Los Alamos County
Community Development Department
PLANNING & ZONING COMMISSION

Public Hearing Date: June 12, 2019
Subject: Case No. SIT-2019-0035
Property Owner: Canyon Walk Housing, LLC / Bethel Development, Inc.
Applicant: Daniel Terlecki; Bethel Development, Inc; Agent
Case Manager: Ryan Foster, Principal Planner

Case No. SIT-2019-0035:

SITE PLAN

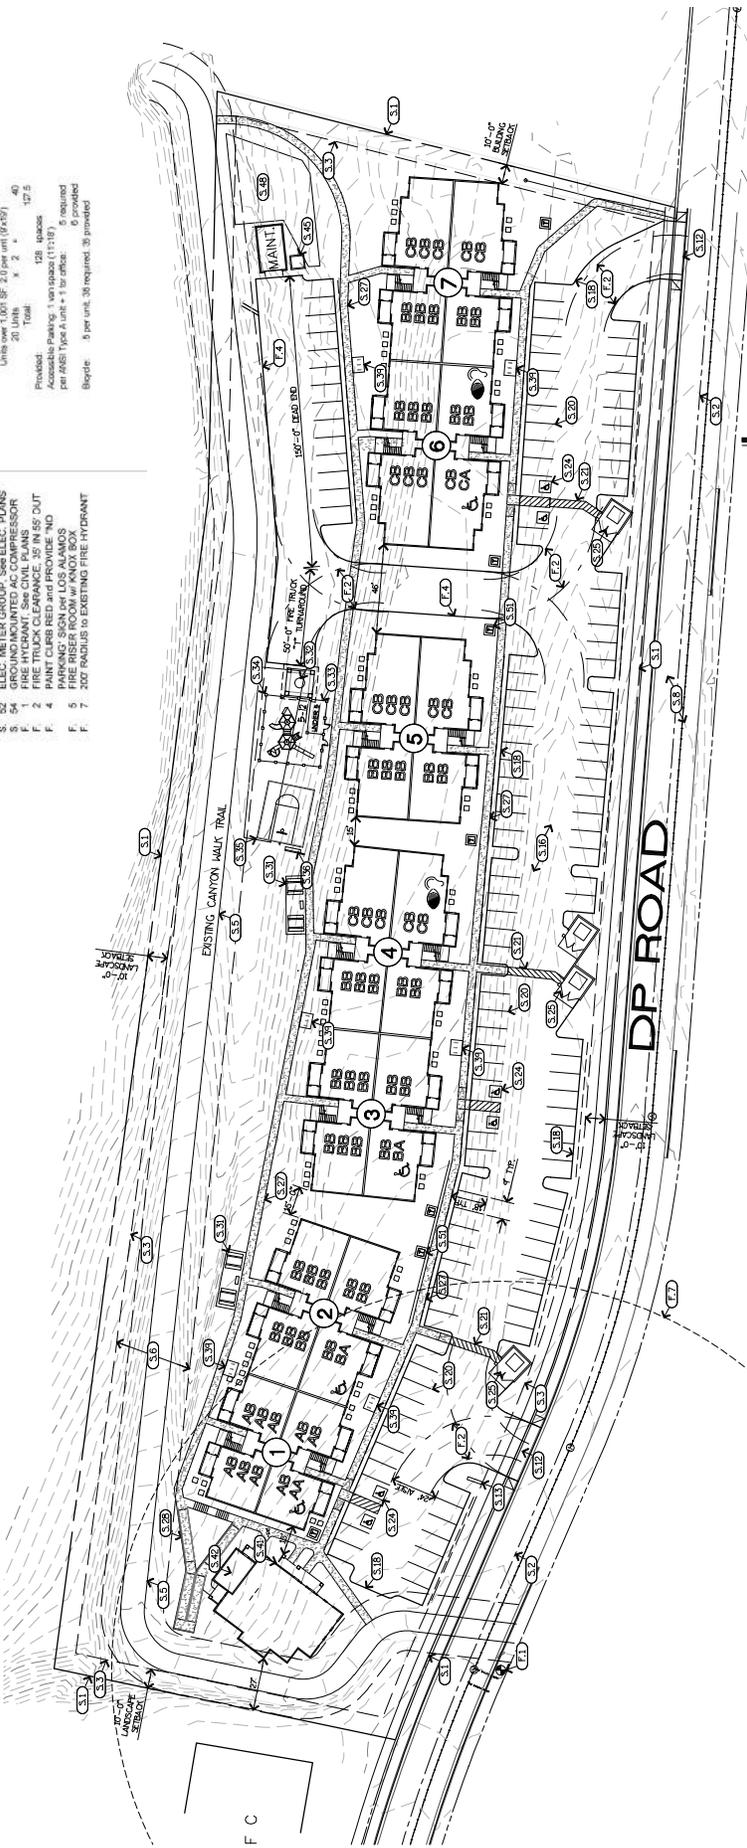
1. A landscape buffer shall be provided between the curb and sidewalk, from the trail to the east.
2. The southwest parking stall shall be removed from the Canyon Rim trail easement.
3. The plans shall detail the location of the drainage inlet and outlet to the canyon.
4. A revised and replatted Site Plan shall be prepared and submitted prior to filing an application for a Building Permit, incorporating all items as required by the Planning & Zoning Commission at the public hearing.
5. A final utility plan shall be submitted prior to building permitting.
6. The final plat shall depict the dedicated right-of-way on DP Road.
7. The crosswalk to the Canyon Rim trail shall be illustrated on the site plan.

Parking: The applicant's site plan includes one-hundred and twenty-eight (128) regular parking spaces, six (6) ADA-accessible parking spaces, and thirty-six (36) bicycle spaces. As a condition of site approval as stated in this staff report, the southwest parking stall will be required to be removed from the trail easement, resulting in one-hundred and twenty-seven (127) regular parking spaces.

Sec. 16-369 Handicap parking indicates for 101-300 regular parking spaces 8 handicap parking spaces are required. At the time of building permit submittal, the applicant will need to indicate 8 handicap spaces instead of 6 handicap spaces as shown on the current site plan submittal.

The applicant shall be required to appropriately sign and stripe the crosswalk across DP Road to the multi-use trail. ADA ramps should be shown at the handicap parking spaces.

The site plan should show the proposed site lighting pole locations. A photometric plan will be required with the building permit submittal. [Engineering]
